RE: Horse Heaven Wind Farm Draft Environmental Impact Statement (Docket Number EF-210011)

This comment letter is submitted on behalf of Audubon Washington (“Audubon”), a state field office of the National Audubon Society, in response to the Horse Heaven Wind Farm project (“Project”) Draft Environmental Impact Statement (“DEIS”).

Figure 1. Arid Lands Initiative Core Areas and Linkages (USFWS 2015).

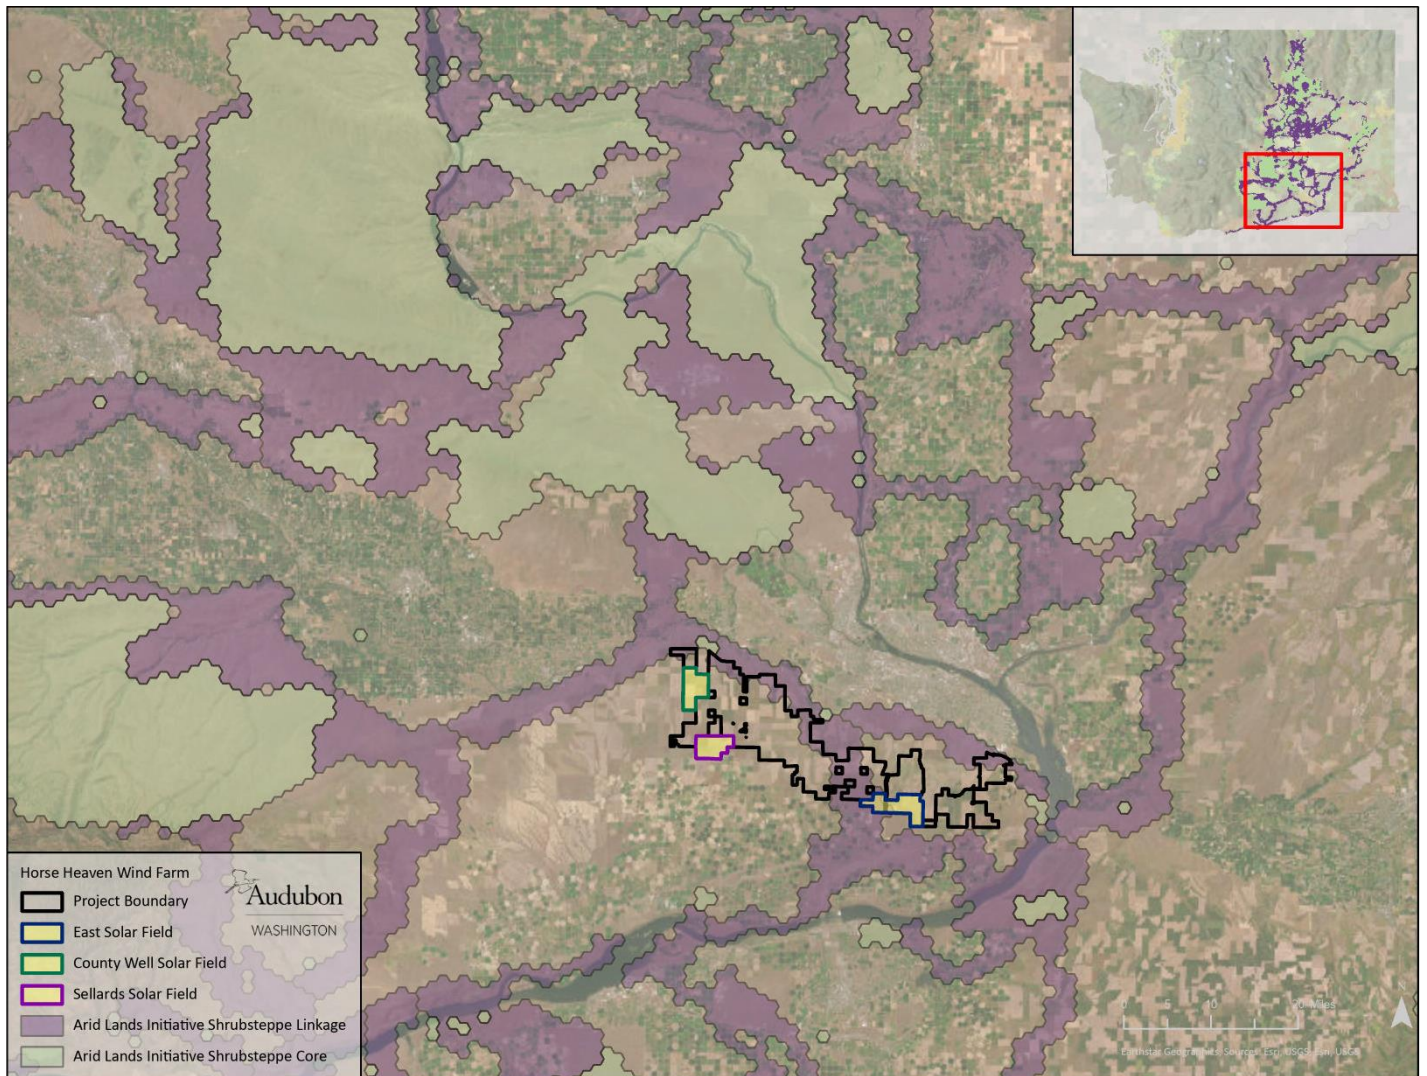
Based on the location of the Project micro-siting corridors and proposed east solar field in *Section 2.1.1 Figure 2.2* the Project will disrupt east-west and north-south landscape connectivity and Ferruginous Hawk foraging habitat within the Arid Lands Initiative Fourmile Canyon Primary Linkage Area (PLA #36) (USFWS 2015) (Figure 1).

Figure 2. Ferruginous Hawk Nest Density (source: WDFW).

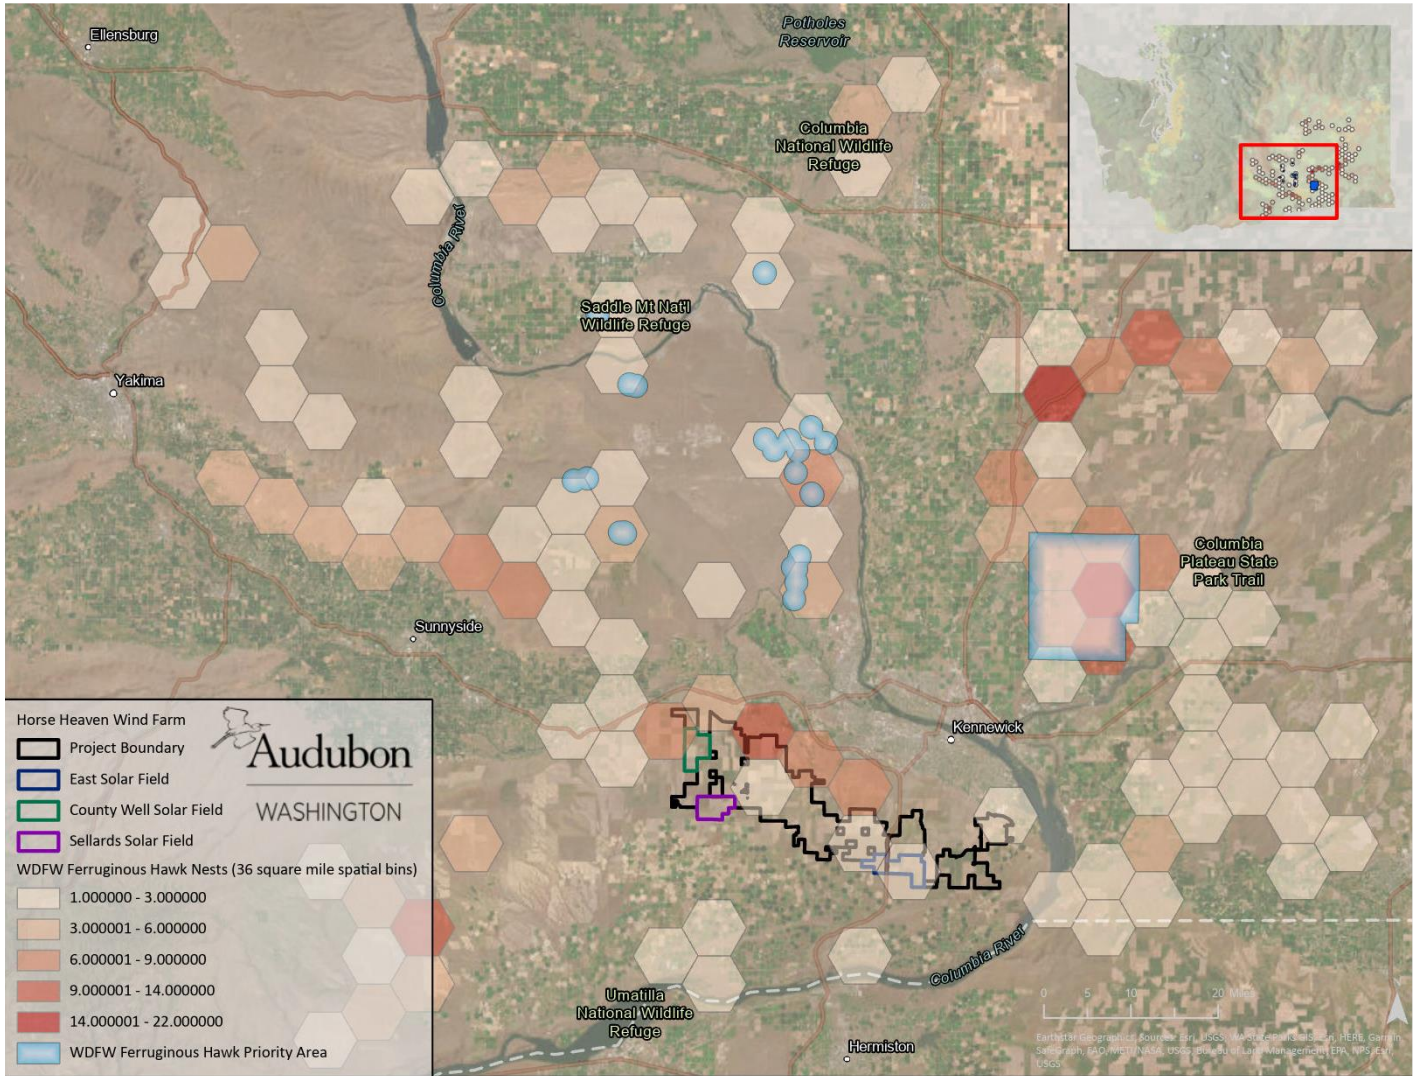
Analysis Issue 2B: Ferruginous Hawk. Ferruginous Hawk is a State Endangered species that is suffering steep declines, both locally in Benton and Franklin Counties and state-wide (Hayes and Watson 2021). *In Section 4.6.2.4 Special Status Species*, the DEIS states that “*PHS data document 41 Ferruginous Hawk nests within 2 miles of the Lease Boundary, including 10 within the Lease Boundary (WDFW 2022a).*” Breeding Ferruginous Hawks are sensitive to the density of wind turbines. A recent study of *Buteo* hawk nest success and post-fledgling survival in the Columbia Plateau Ecoregion observed decreased nest success for Ferruginous Hawks and lower *Buteo* hawk fledgling survival in association with greater wind turbine densities (Kolar and Becher 2016). According to Ferruginous Hawk nest data we acquired from WDFW, the Project is in an area of relatively high importance for Ferruginous Hawk nesting activity in Washington State, warranting careful consideration of potential impacts to the statewide population (Figure 2).

Figure 3. Proportion of Project Lease Boundary and habitat types within 6-miles (home range) of Ferruginous Hawk nests. Only the SW corner is outside the Hawk's home range.

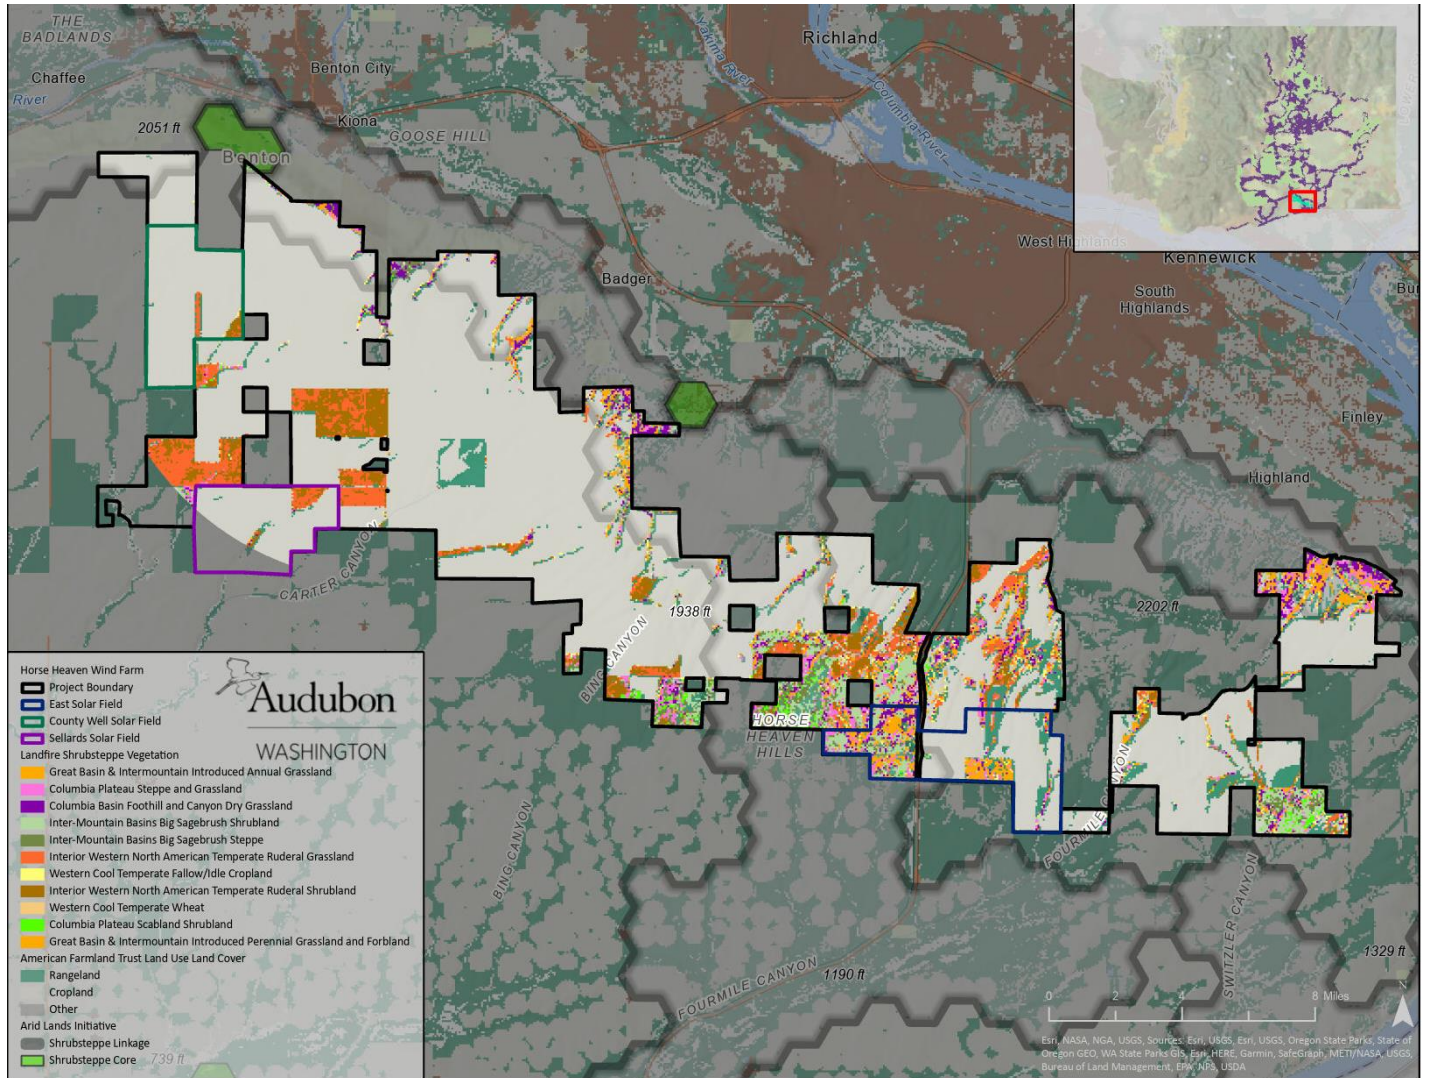
The DEIS calculates potential direct and indirect habitat loss based on a Ferruginous Hawk 2-mile core habitat and 6-mile range habitat for documented nest locations. There appears to be an issue with this analysis. For reasons that are unclear, the DEIS limits the analysis to just two active nests that were observed by the Applicant during field surveys, rather than all documented nests in the vicinity. According to the state Ferruginous Hawk species expert, Ferruginous Hawk may reoccupy vacant nest territories after many years of absence, and protection of nesting territory viability, including unoccupied nest territories, is a core component of species recovery in the state (J. Watson, pers. communication). The DEIS estimate of potential direct loss of ~7,800 acres of Ferruginous Hawk range habitat and indirect loss of ~42,849 acres of range habitat is based on just two nests and vastly underestimates potential impacts to the species. Based on telemetry data in Washington and Oregon, the average home range of a nesting pair is ~10km (6.2 miles) radius from the nest (unpublished data reference by J. Watson in Jansen et al. 2022). All nests within this radius of the project should be considered in the Applicant's calculation of direct and indirect loss. According to our analysis, there are 51 documented nest sites within 6 miles of the lease boundary, which would result in impacts to Ferruginous Hawk core and range habitat across the majority of the Project Lease Boundary area (Figure 3), including native shrub-steppe habitat within the Fourmile Canyon Linkage area.

Raptors like Ferruginous Hawk are at high risk for mortality from wind turbines because they have wind-specific flight behaviors that increase their likelihood of encountering turbine blades (Tethys.pnnl.gov: raptors). The Applicant's population viability analysis demonstrates that reduced survival and territory occupancy resulting from the project can have synergistic effects on ferruginous hawk populations viability (Jansen and Swenson 2022). The scale of habitat loss and risk of mortality, territory abandonment and reduced foraging and nest success associated with the proposed Project is clearly incompatible with the species' recovery in Washington. Proposed mitigation measures (below) to site Project components away from Ferruginous Hawk core habitat "when feasible" is insufficient and leaves too much discretion to the Applicant to reduce the potential impact of the Project on the population. The proposed micrositing corridors and layout of turbines under Option 1 and Option 2 include 69 and 41 turbines, respectively, within the 2-mile core area buffer for Ferruginous Hawk, and may cause decreased nest success and/or abandonment of those territories (Figure 4a, Figure 4b). All PHS Ferruginous Hawk nests within the Lease Boundary should be buffered at a minimum of 2 miles from turbine locations, and loss of core and range habitat for all documented nest territories within 6 miles of the turbines should be mitigated.

Figure 4a. Sixty-nine of the 244 proposed turbines in Layout Option 1 are within 2 miles of Ferruginous Hawk nests.

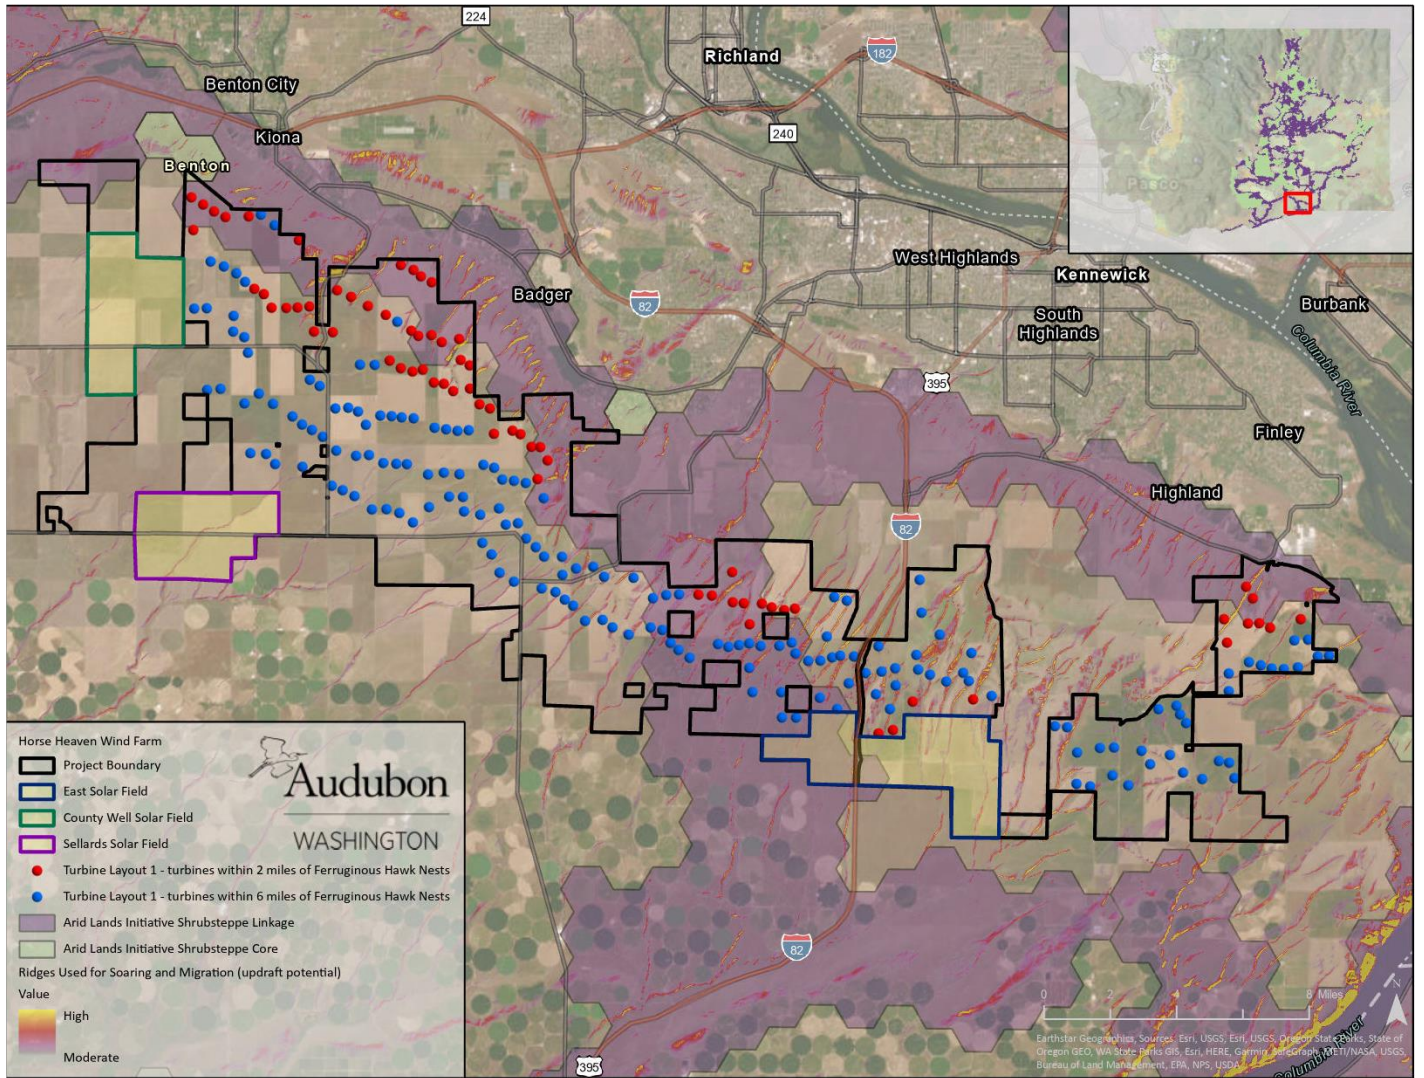
- Eliminating turbines within a 2-mile radius of Ferruginous Hawk nests and between Sheep and Webber Canyons;
- Reducing the density of turbines in the Fourmile Canyon linkage area (e.g., Figure 4a, 4b);
- Designing the East Solar Field to eliminate the creation of a pinch point for wildlife connectivity, and;
- Conducting habitat restoration within the Fourmile Canyon linkage area.
